The Great Grid Upgrade

Norwich to Tilbury

Design Development Report

AENC-NG-CNS-REP-0005

Figure 5.20 Alignment at Fordham and Aldham

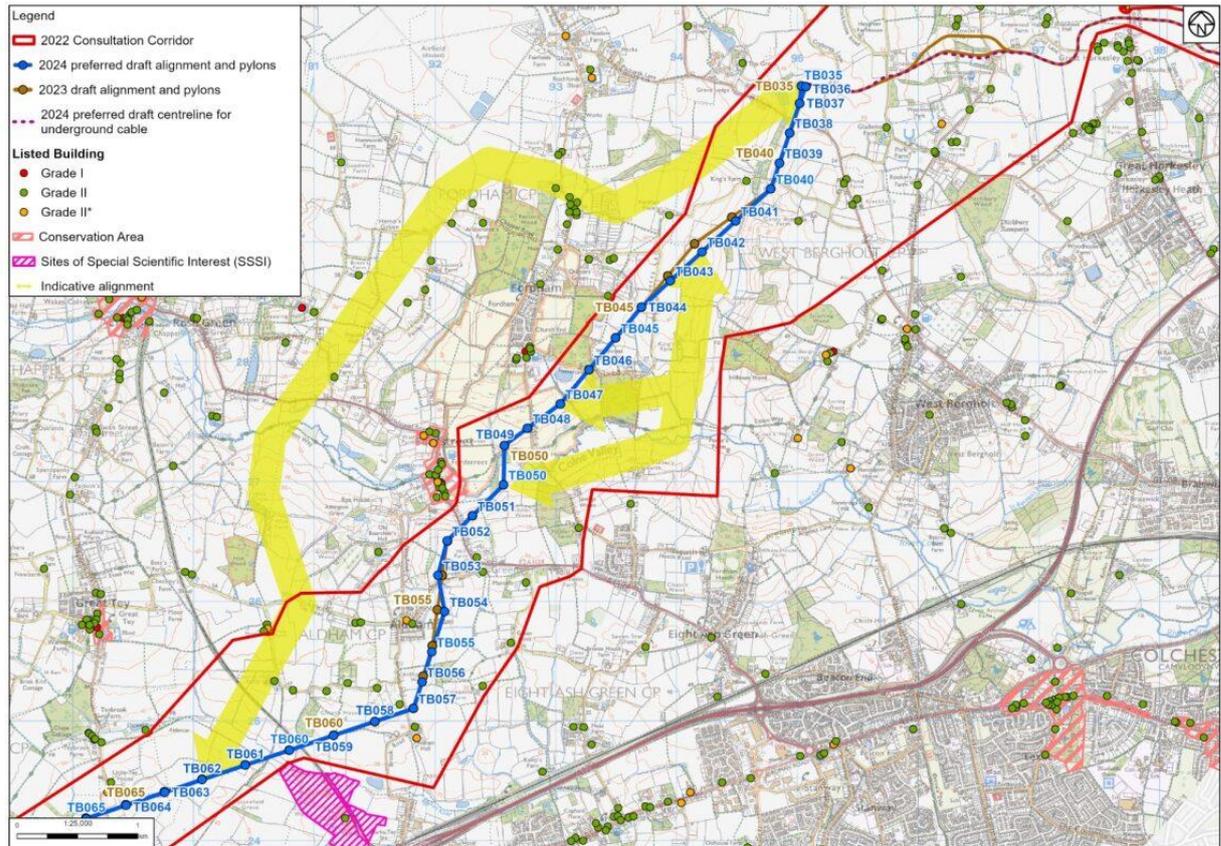
- 5.4.136 Consideration has been given to an alternative alignment suggested in feedback to pass to the west of the villages of Ford Street, Fordham and Aldham to reduce potential effects rather than remaining on the 2023 preferred draft alignment that passes to the east (see Figure 5.20). A provisional alignment, based on an indicative sketch provided in feedback, was developed applying the same route development approach underpinning the 2023 preferred draft alignment. The alternative would commence at the western Great Horkesley CSE compound heading south-west then west passing just to the south of Houd's Farm. It would then turn southwards to pass between Hemp's Green and Sutton's Farm, then continuing to the west of Penlan Hall and Oak Farm, crossing the A1124 between properties at Braeburn and White Acres. It would then route to the east of Wick Farm and Hoe Wood, and west of Hoe Farm before crossing the railway and connecting to the 2024 preferred draft alignment around TB063.

- 5.4.144 In response to feedback, other localised alternatives over shorter parts of the 2023 preferred draft alignment have also been considered (also shown on Figure 5.20). These included more easterly crossings of the Colne Valley, including paralleling Fossetts Lane, and crossing south of Watercress Hall. On review it was identified that all such alternatives were substantively constrained to the south of the River Colne due to restrictions presented by residential properties around Fordham Heath and Eight Ash Green, and Fiddlers Wood Ancient Woodland. There are particular constraints at Fordham Bridge where the combination of utility infrastructure, ancient woodland, flood zone and watercourse are considered to preclude overhead line routeing. On this basis these more easterly alternatives were not preferred and were not taken forward.

- 5.4.138 Whilst proximity of the western alternative to Wormingford Airfield is noted, the runway orientation and likely distance from the alignment are considered to reduce the potential for the Project to have effects on flight activity. These would however be considered to be greater than on the 2023 preferred draft alignment to the east given the closer proximity.

Figure 5.21 Alignment at Aldham

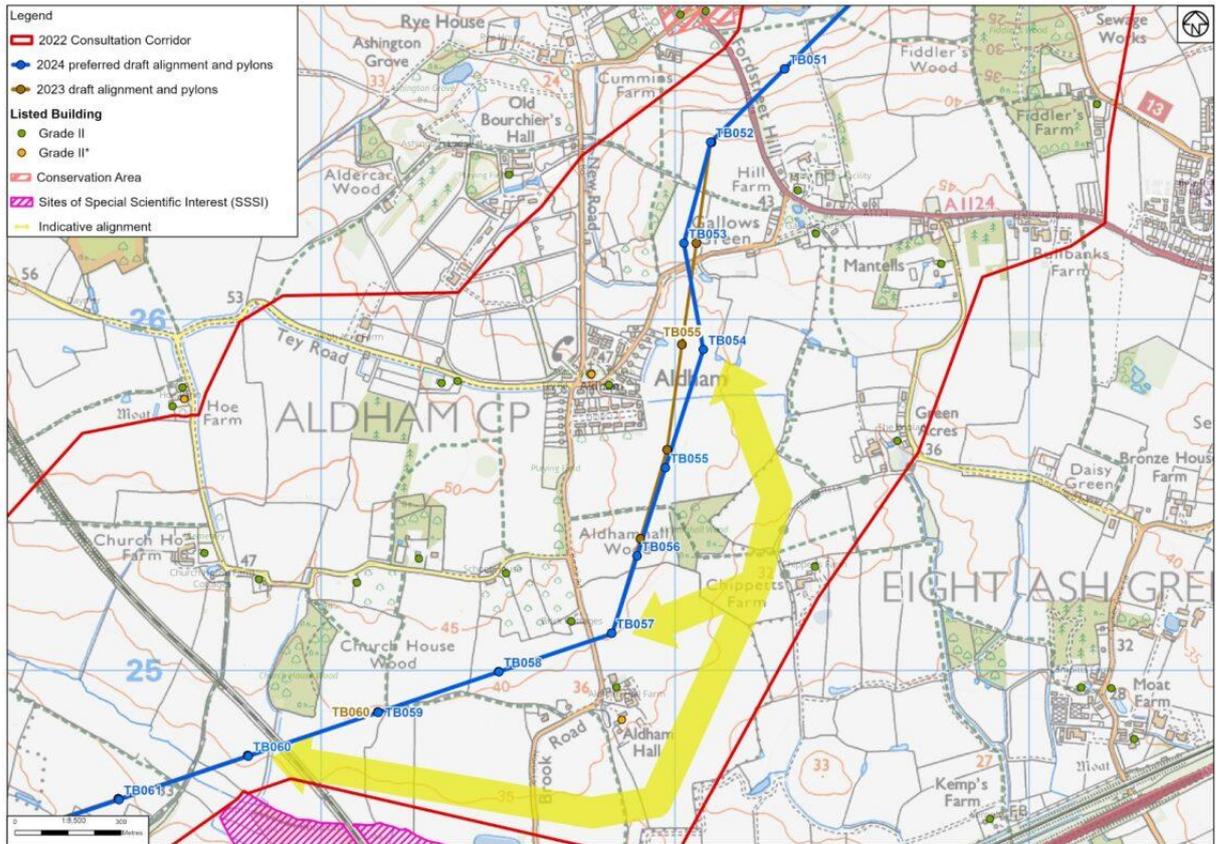
- 5.4.150 A number of alternatives to divert the alignment to pass to the east and south of Aldhamhall Wood by extending the alignment on from TB053 to TB054 by around two or three spans were considered (see Figure 5.21). These included reconnecting at TB057 (approximately 300m longer with one additional pylon required and one more angle pylon) and further alternatives passing to the south of Aldham Hall (approximately 600 m longer with two additional pylons required and two more angle pylons). Whilst noting that the alternatives all reduce proximity to a number of residential properties at the south-east corner of Aldham (noting most views are side views), effects are transferred to some degree to others further to the west and particularly to Chippetts Farm which is also a Grade II listed building. This would have open views of a nearby pylon and approaching alignment.

- 5.4.151 On balance given the longer alignment and increased heritage effects these alternatives were less preferred.

Figure 5.22 Alignment at Little Tey

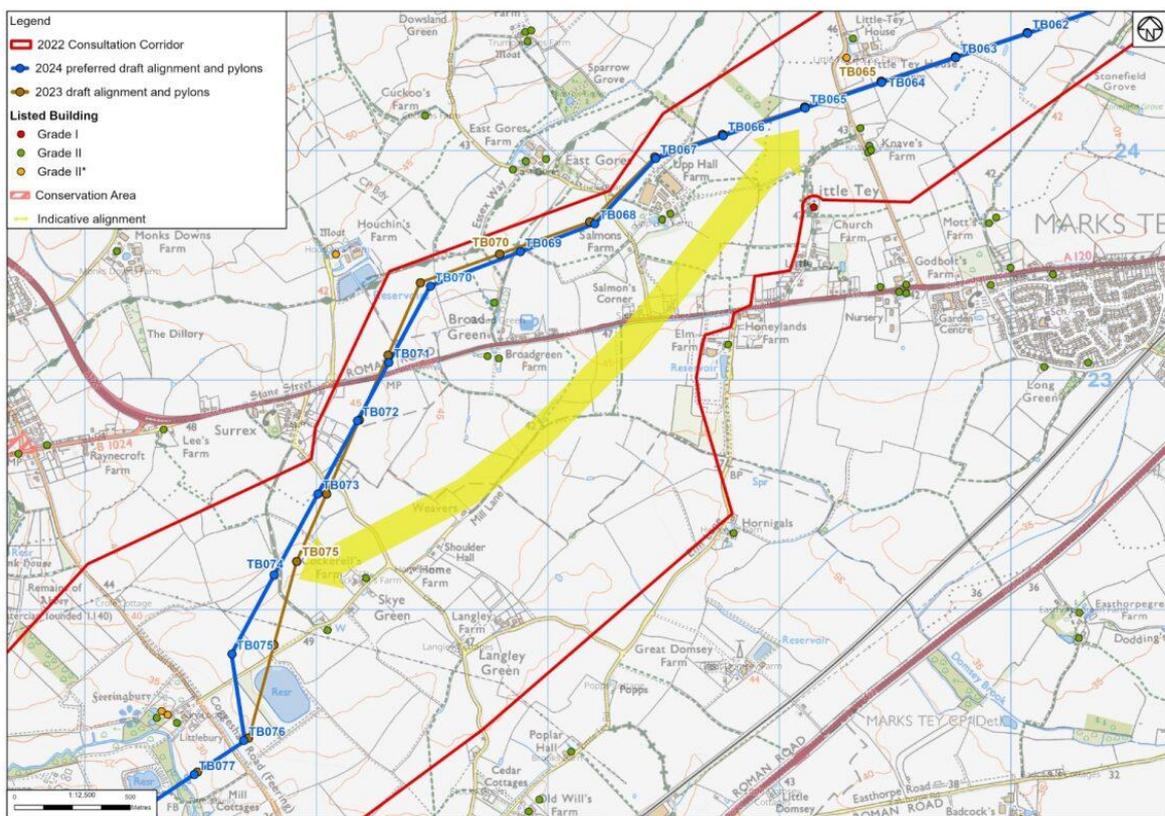
- 5.4.156 Other feedback proposed an alternative routeing to the south side of Upp Hall Farm (see Figure 5.22), which would be from around TB065 (on the 2024 draft alignment). This alternative would increase effects on the Grade I Listed Church of St James at Little Tey and has potential to increase effects on residential amenity by adopting a crossing point where the separation to properties is reduced compared with the 2023 preferred draft alignment. For these reasons this alternative is less preferred and routeing to the north side of Upp Hall Farm has been retained within the 2024 preferred draft alignment.

5.4.157 The 2023 preferred draft alignment has however been slightly modified from where it passes Upp Hall Farm and onwards to the south to respond to feedback to reduce oversail of a carp fishery (oversailed by the span between TB076 and TB077 in the 2023 preferred draft alignment and now adjacent to TB075 in the 2024 preferred draft alignment). The 2023 preferred draft alignment may have restricted fishing on potentially upto half the lake depending on final alignment. Additionally, feedback also requested that National Grid seek to either position pylons on field boundaries or sufficiently clear of the field boundaries so as not to impede farm equipment. An alternative alignment was developed which changes the alignment to pass to the west of the fishing lake avoiding oversail and thus not restricting fishing. This moves TB075 and TB076 (as identified on the 2023 preferred draft alignment) further from and closer respectively to residential properties though separation of around 250 m is still achieved from the closest. On balance the alternative is preferred and has been taken forward in the 2024 preferred draft alignment.

Figure 5.23 Alignment to east of Rivenhall

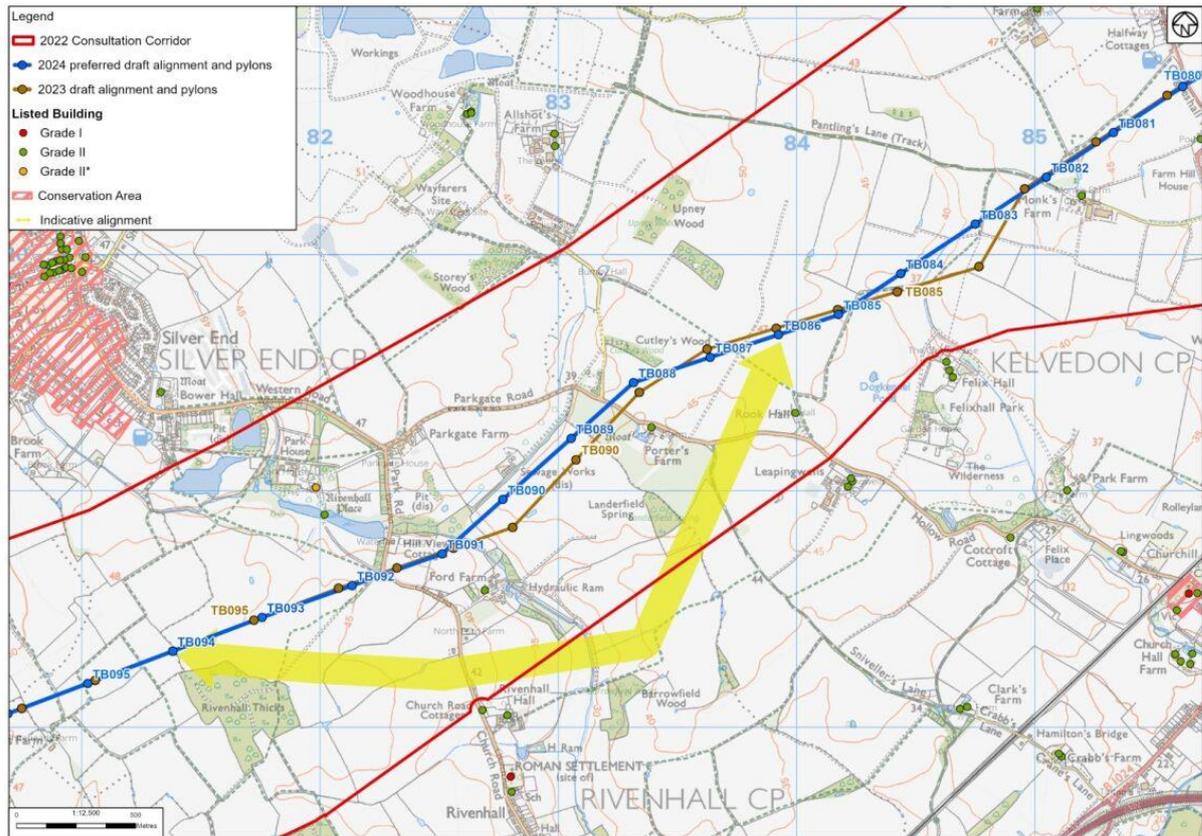
- 5.4.167 A further alternative raised in feedback (see Figure 5.23) to move the alignment (at TB92 to TB93 on the 2023 preferred draft alignment) slightly further south has also been considered. With the 2023 preferred draft alignment this would have added a number of additional angle pylons to route around various residential properties and was less preferred for this reason. The change to the 2023 preferred draft alignment makes the requested change easier to achieve by continuing the alignment straight on from TB091

(2024 preferred draft alignment) though it still requires one additional angle pylon to reconnect to the south. This alternative would also transfer effects to a different residential property on Church Road to the south-east and would position a pylon on land proposed for solar panels on the proposed Park Gate solar farm (noting that at the time of writing, confirmation was awaited of a possible appeal to planning refusal). On the basis of the greater effects, mostly related to the solar farm) the alternative is considered less preferred. The proposed draft order limits have however been extended in this location to allow for a further small adjustment to the alignment, which would also allow reduction of effects on a group of trees, should the solar farm not progress.

Figure 5.24 Alignment at White Notley and Fairstead

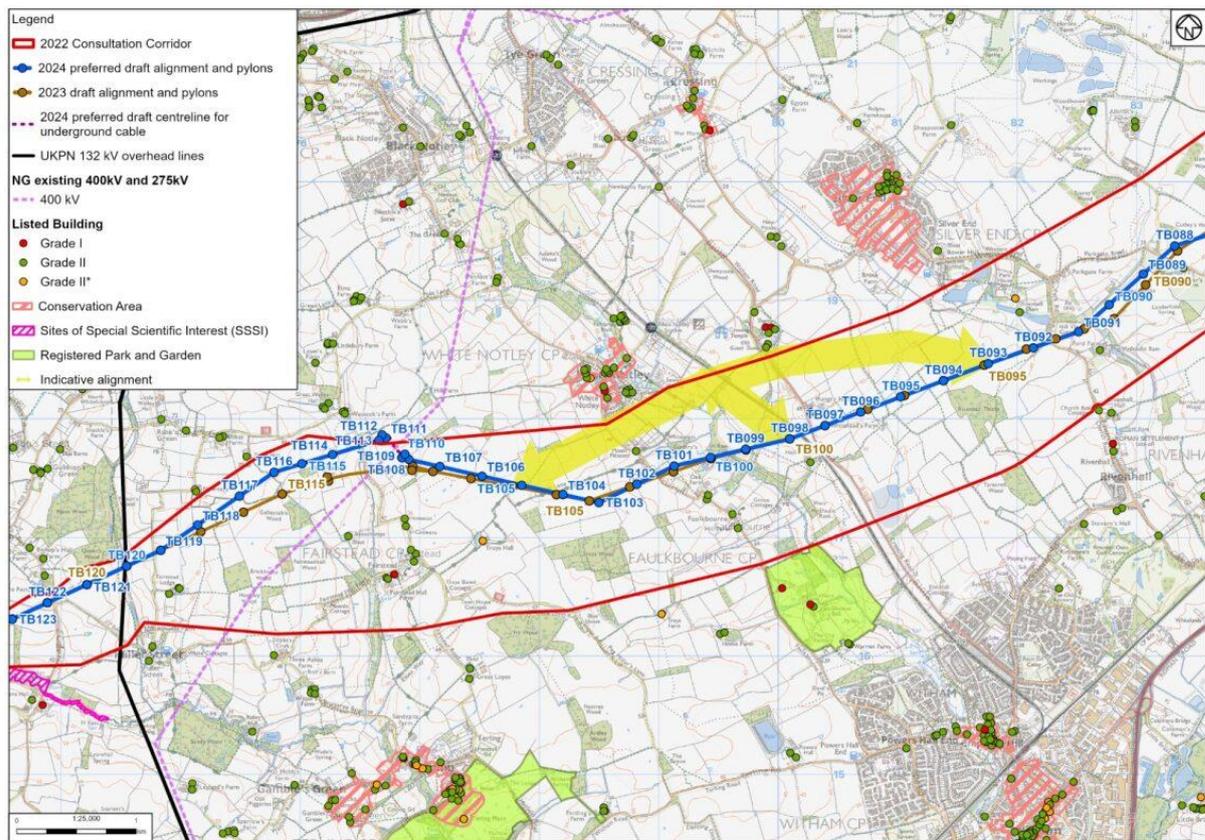
- 5.4.168 Continuing within Section E, feedback from respondents requested consideration of various alternatives seeking to move the alignment further to the north of Faulkbourne (see Figure 5.24), in particular proposing alignments that would pass close to the immediate south of White Notley and / or Crossing Temple. Although there would be a reduction in visual and heritage effects to Faulkbourne Hall and certain residential and / or listed properties from such alternatives, they would also lead to a transfer of effects to other receptors. This includes transferring effects to a greater number of other similar residential properties or heritage assets (including similar grade listed buildings and a scheduled monument) and in some cases were considered likely to lead to a greater magnitude of effect. Alternatives here were also considered to be less consistent with the Holford rules and overall were not preferred.

- 5.4.170 An oversail, by the 2023 preferred draft alignment, of the corner of a pitch (see Figure 5.24) and specifically the western goal posts to the south-east of White Notley has been identified. Whilst any potential microshock risk could have been mitigated through the use of plastic goalposts, it was considered there was a residual concern that future replacements may inadvertently overlook the potential risk. The angle pylon has been moved and is now positioned at TB101 (on the 2024 preferred draft alignment) with the degree of direction change slightly increased to avoid the oversail of the goal (removing the microshock risk) whilst not moving the alignment closer to residential properties to the west side of Church Hill.

Figure 5.25 Alignment at Great Waltham

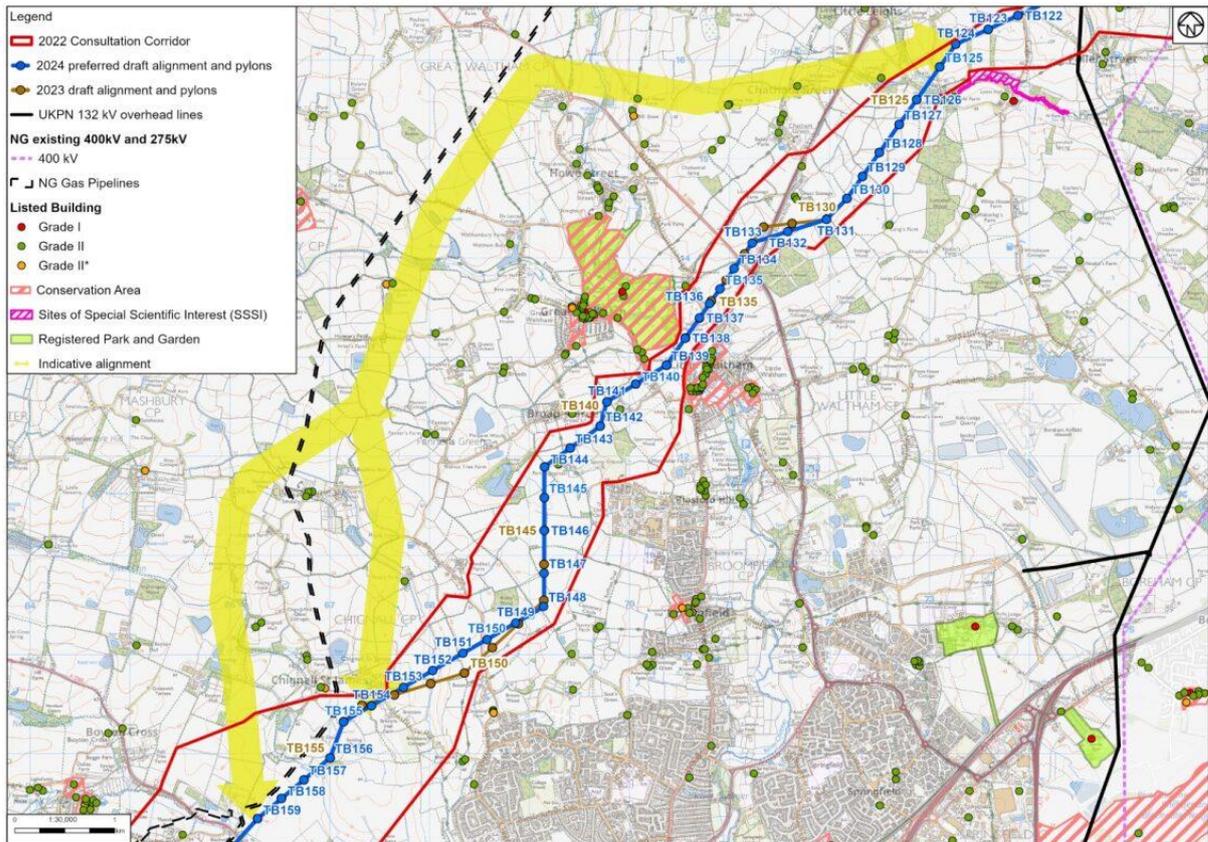
5.4.179 Several respondents restated their preference for a more western alternative towards Pleshey (see Figure 5.25) though identified no new factors nor change to material considerations to support their preference. National Grid has backchecked and has considered an alternative that would divert west from around TB124 / TB125 on the 2024 preferred draft alignment passing to the north of Warner’s Farm before turning southwards. Routing would be likely to stay to the east of the gas pipeline to maintain separation from Pleshey. Alternatives to pass Chignall Smealey and Chignall St James either to the east or west may be available with a preference to pass to the west as a more direct alignment.

Figure 5.27 Alignment north of Broomfield

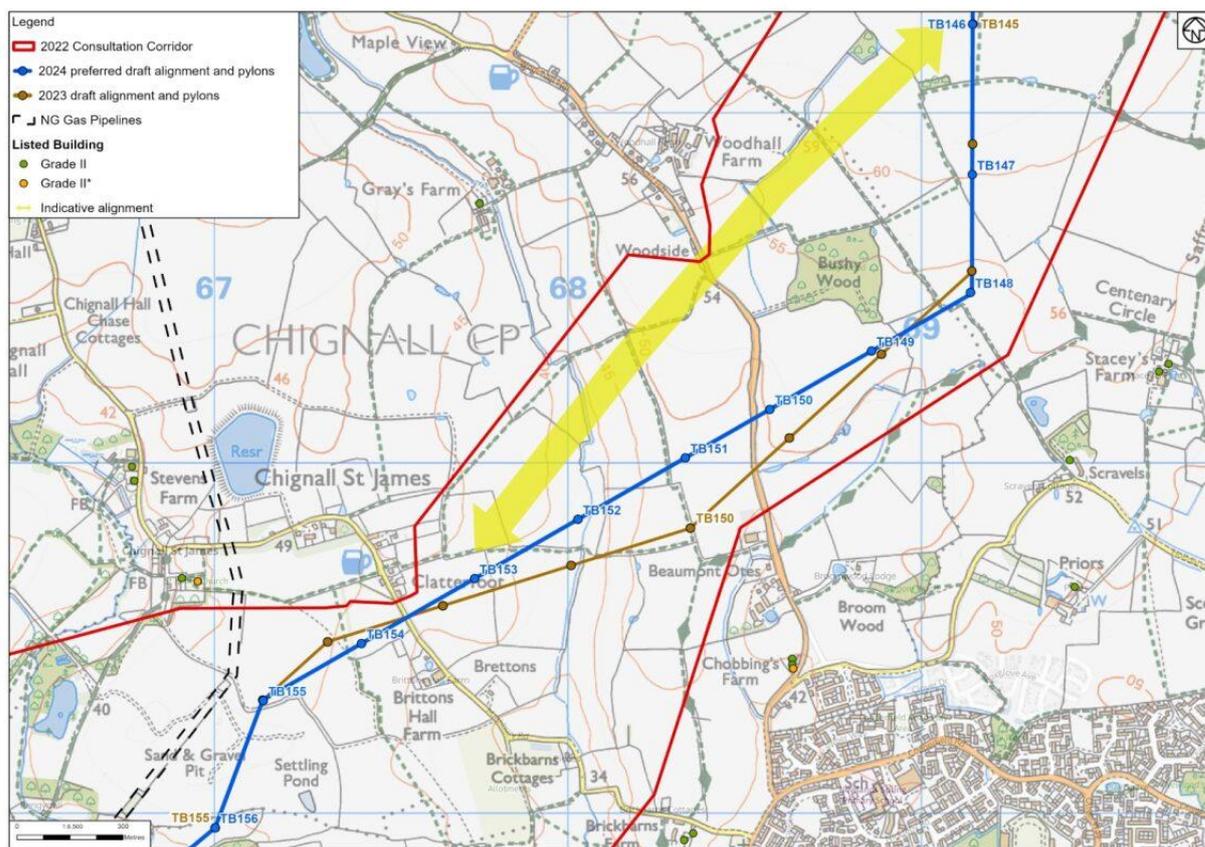
- 5.4.188 To the west of Broomfield, in response to feedback, the 2023 preferred draft alignment has been straightened between TB148 and TB155 (identified as TB147 and TB154 respectively in 2023) (see Figure 5.27) replacing four angle changes with two slightly greater angle changes.

- 5.4.189 A preference for an alternative alignment was restated by respondents seeking to move the alignment to the north of Bushy Wood by adopting a straight alignment broadly between TB146 and TB153 (on the 2024 preferred draft alignment). This alternative would lead to increased effects on residential properties on Woodhall Hill where separation to the draft alignment would be reduced to around 150 m. Following the straightening from TB147 to TB155 (2024 preferred draft alignment) noted above, separation to properties to the south is currently in excess of 350 m with the separation to the properties to the north slightly greater at around 450 m. A midway alignment cannot be achieved due to the constraint of the ancient woodland at Bushy Wood. In the absence of other or additional factors and no new material considerations being identified it is considered that an alternative to the north of Bushy Wood is less preferred and it has not been taken forward.

Figure 5.28 Alignment west of Writtle

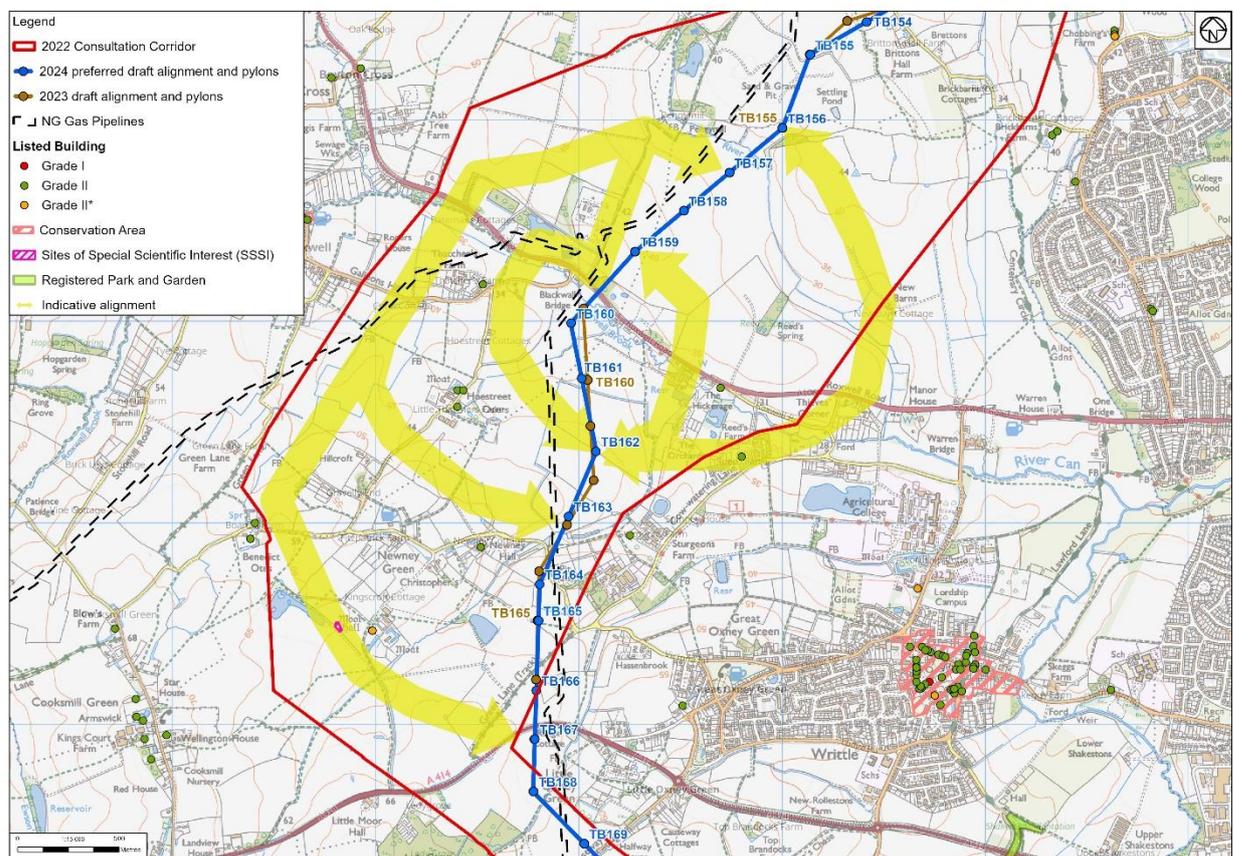
- 5.4.190 Feedback relating to land to the north-west of Writtle (see Figure 5.28), to the south of Brittons Hall Landfill, requested avoiding a site used for a scouting and guiding Jamboree every four years, suggesting it could be addressed by alternatives diverting to either east or west.
- 5.4.191 An alternative diverting to the eastern edge of the site would adversely affect land identified as a Strategic Growth site, as well as having to cross Roxwell Road between The Hickerage and Thieves Corner. At this location changes of direction would be required and the space between residential properties would be considerably reduced.

5.4.193 Feedback also requested consideration of an alternative deviating from the 2023 preferred draft alignment close to the gas compressor site to pass immediately to the west of the Hare public house. The gaps between properties would however be reduced and there would be a transfer of and increased effects on residential amenity compared with the 2023 preferred draft alignment. Requests for other alternatives further west were also repeated from the 2022 consultation but, as identified in the 2023 Design Development Report these would require much longer routes with greater angle changes and the transfers of effects to a larger number of residential properties. These therefore continue to remain less preferred. On balance therefore the 2023 preferred draft alignment continues to be considered preferable to other alternatives and has been taken forward.
